**Subject:** FW: External: RE: Rumford WQ sampling - site visit notes

## Summary notes for the June 24, 2020 – Rumford Falls Project MDEP Site Visit

### **Supplement #1: Summary notes for the June 24, 2020 – Rumford Falls Project MDEP Site Visit**

Figure 1. Preferred deployment location downstream of Middle Dam for the temperature/DO logger and macroinvertebrate samplers.

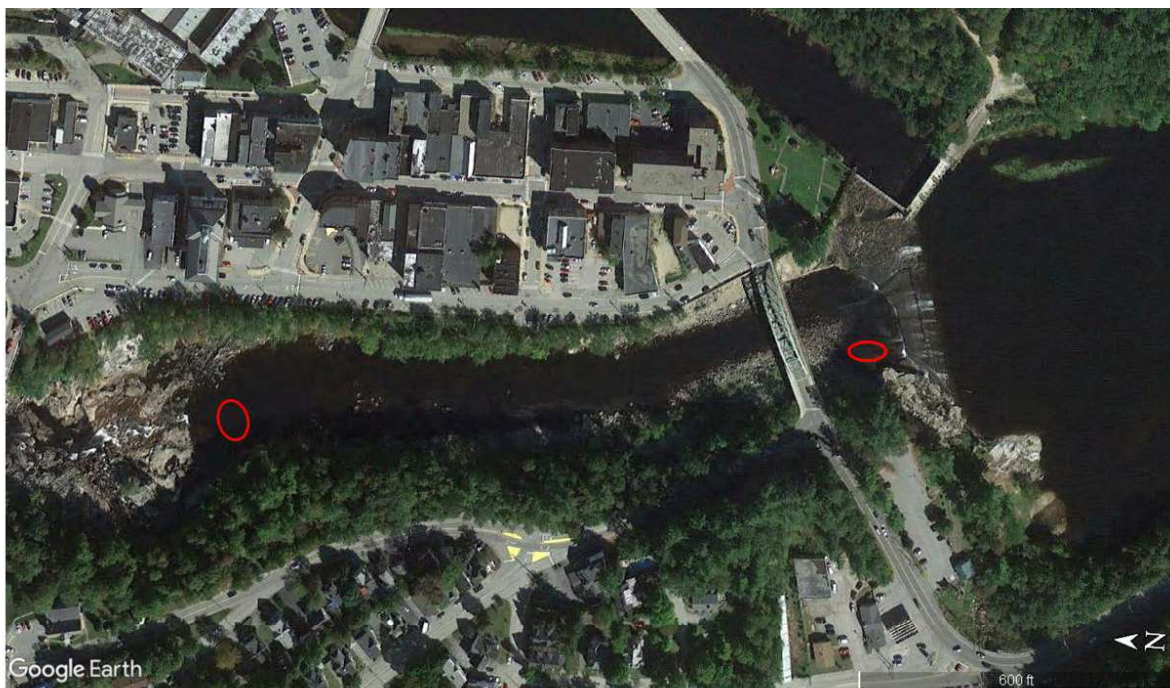
- Logger downstream of Middle Dam – preferred location
  - See Figures 1 and 2.
  - Logger should be placed in location downstream of bypass pipes and dam spouts so that unit remains submerged for duration of monitoring period.

- Normandeau to collect photos of this area during June 29 trophic sampling to provide to MDEP for confirmation that appropriate wetted habitat is available at this location when no spill flows are present over Middle Dam.

- Normandeau to select specific location with appropriate substrate and adequate water depth for deployment period in the vicinity of the temperature/DO logger (Figures 1 and 2).

Figure 3. Alternate deployment location downstream of Middle Dam for the temperature/DO logger and macroinvertebrate samplers.

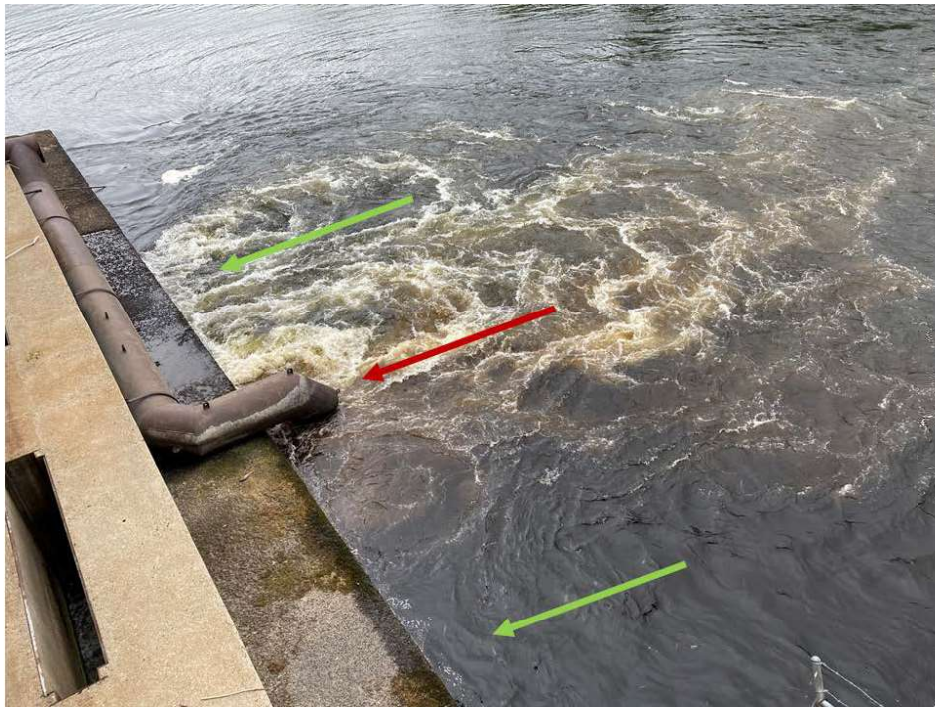
- Logger downstream of Middle Dam – secondary location
  - See Figures 2 and 3.
  - In the event it is determined that sufficient wetted area and water depths at the preferred location are not available then logger will be installed in pool habitat located just upstream of the bedrock cascade portion of bypassed reach.

- In the event it is determined that sufficient wetted area and water depths at the preferred location are not available then invertebrate samplers will be installed in pool habitat located just upstream of the bedrock cascade portion of bypassed reach.

Figure 5. Power canal deployment location for the temperature/DO logger to be considered representative of conditions downstream of the confluence of the bypassed reach and lower powerhouse discharge.

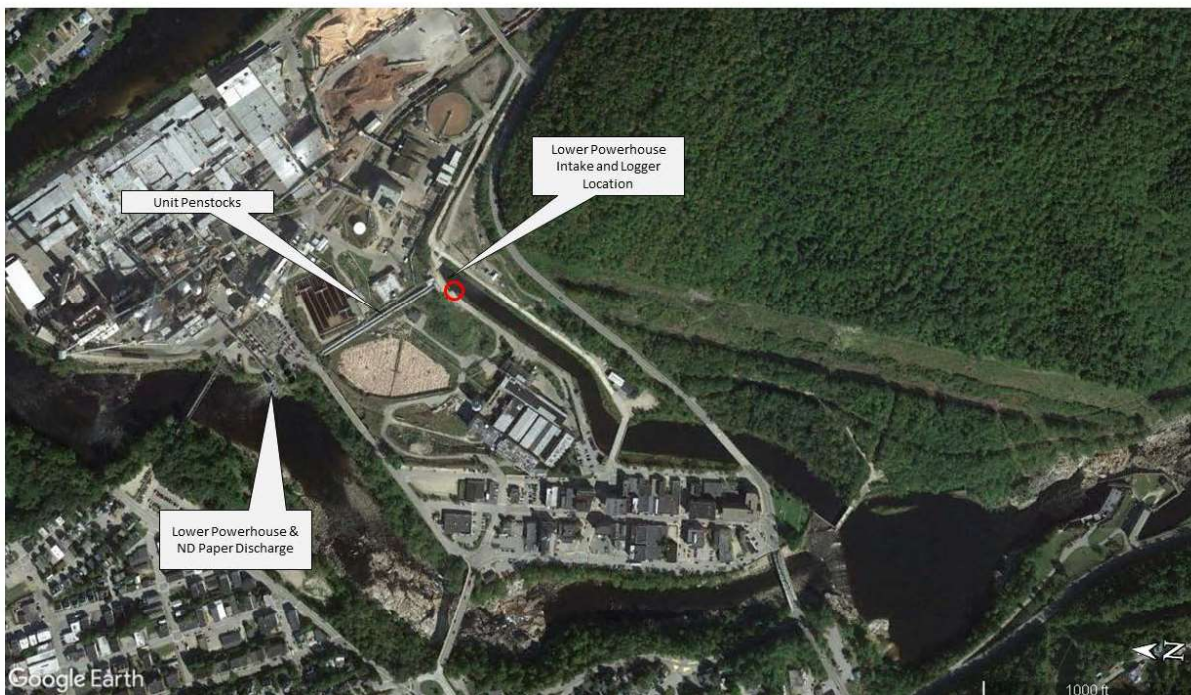
- Maine DEP indicated that the placement of a temperature/DO logger at the downstream end of the power canal (adjacent to the lower powerhouse intake) would be representative of water quality following discharge out of the lower powerhouse (Figures 5 and 6).
